September 11, 1984

Enclosed is the E.C.O. covering the installation of bushings to the aileron bellcranks on the 2-22. Schweizer engineering has also approved this repair for all 1-26 model aileron bellcranks, part number 26121-001.

ENGINEERING CHANGE ORDER								CHG.	LET.
.TLE:		AILERON BELLCRANK INSTALL, WING STA. 181.18							
INC.	BY	EFFECTIVITY	SPARES	PART AFFECTED	No	ECO. SERIAL	22-554		
ECO.	BY	CARD POSTED	YES	TOOLS AFFECTED	No	D.C.R. SERIAL			
DATE	5-10-79	CHECKED	K 5-10-79	STOCK DISPOSITION	---	DWG. NO.	226476 C

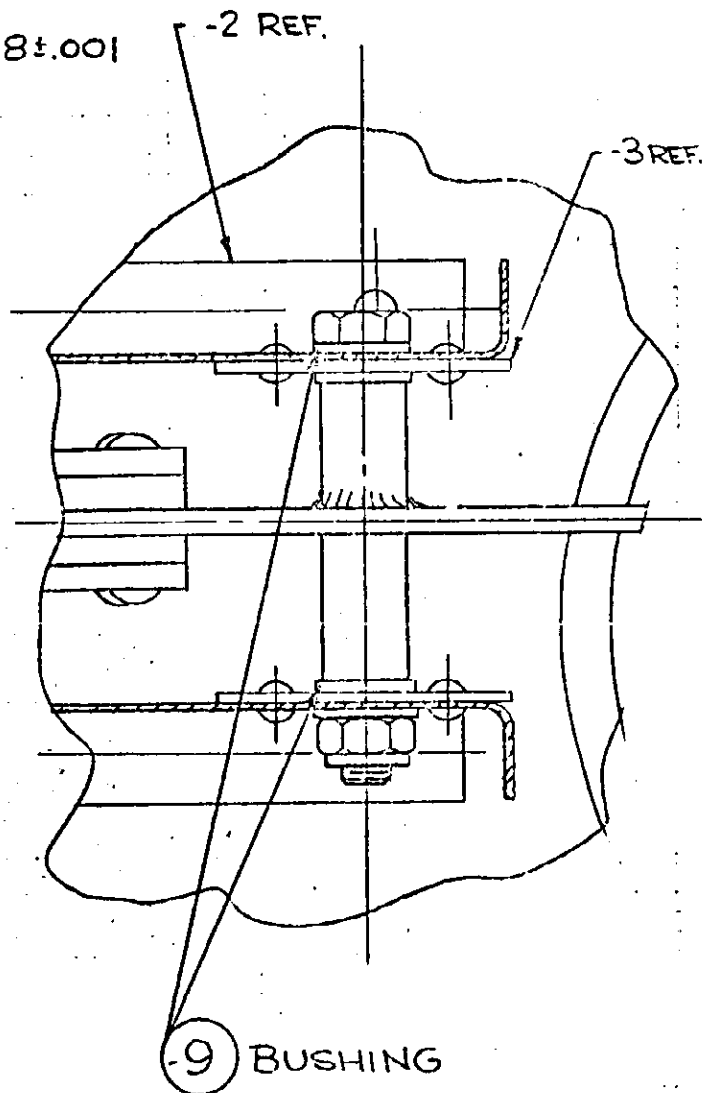
CHANGE: CREATE -9 BUSHING AS SHN. BELOW 2 REQ'D. FOR SPARES USE IN REMOVING SLOP DUE TO WEAR IN BELLCRANK ASS'Y.

TO INSTALL -9 DRILL EXISTING HOLE IN -2 & -3 TO .38 DIA.

NAS 77-4-38
M. 218.10436
P. 10.51
